Attachment – Clause 58 Assessment

Clause 58 comprises design objectives and standards to guide the assessment of new residential development. Given the site’s location within a built-up inner city residential area, strict application of the standard is not always appropriate, whether the proposal meets the objective is the relevant test.

Figure 1 – Officer mark-up showing proposed trees disputed for removal (Arborist's Report)

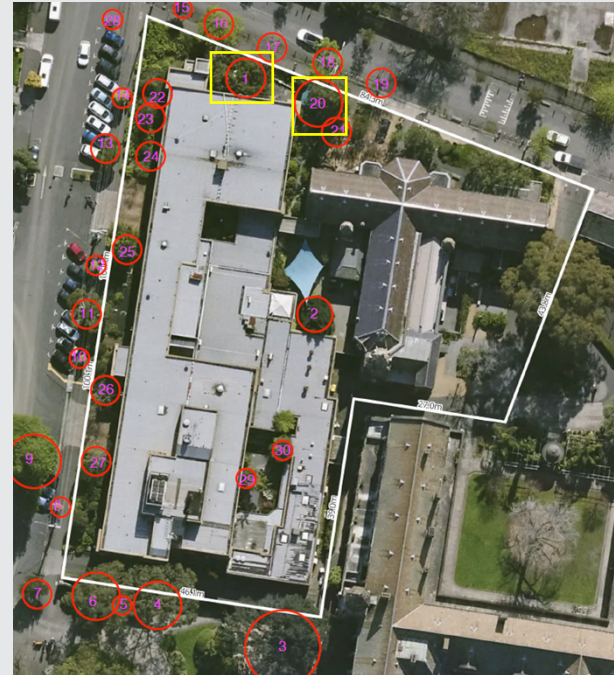
removal of the majority of trees outlined above, however dispute the removal of Tree No. 1 (Flowering Gum) and Tree No. 20 (Silky Oak). These trees are within the St Helliers Street frontage, with the specific locations of these trees shown in yellow boxes in the following image:

Council’s City Works – Open Space team have reviewed the applicant’s arborist report and note that no arboricultural justification has been provided for the removal of Tree 1. Regarding Tree 20, Council’s arborist observes that this tree is in fair condition and good vigour with new growth despite the presence of dead wood and that it still contributes considerable amenity value. The tree also has no TPZ encroachments from the proposed building and could be feasibly retained with tree-sensitive demolition of the adjacent wall.

Considering the proximity of this tree to the existing building and the extent of root system underneath, there is little to no potential to safely retain this tree during demolition and construction works. The arborist's assessment rates the structural integrity of this Tree as Fair-Poor, and it is considered that the structure would become severely compromised during works. As such, removal of this tree is supported.

The removal of Tree No. 20 is not supported. Council's Arborist observes this tree is in fair condition for the species in a Melbourne context, has good vigour with new growth, despite the present of old deadwood, which is likely due to infrequent maintenance. The tree is considered to still have considerable amenity value, and there are no TPZ encroachments from the proposed building. Council's Arborist concludes that this tree could be feasibly retained with tree-sensitive demolition of the adjacent wall.

Based on this advice, a condition will require the retention of Tree No. 20 as well as provision for its protection via a Tree Management and Protect Plan. This management and protection plan will be required for all other retained trees on site as well as street trees within the site's frontage and all neighbouring trees.
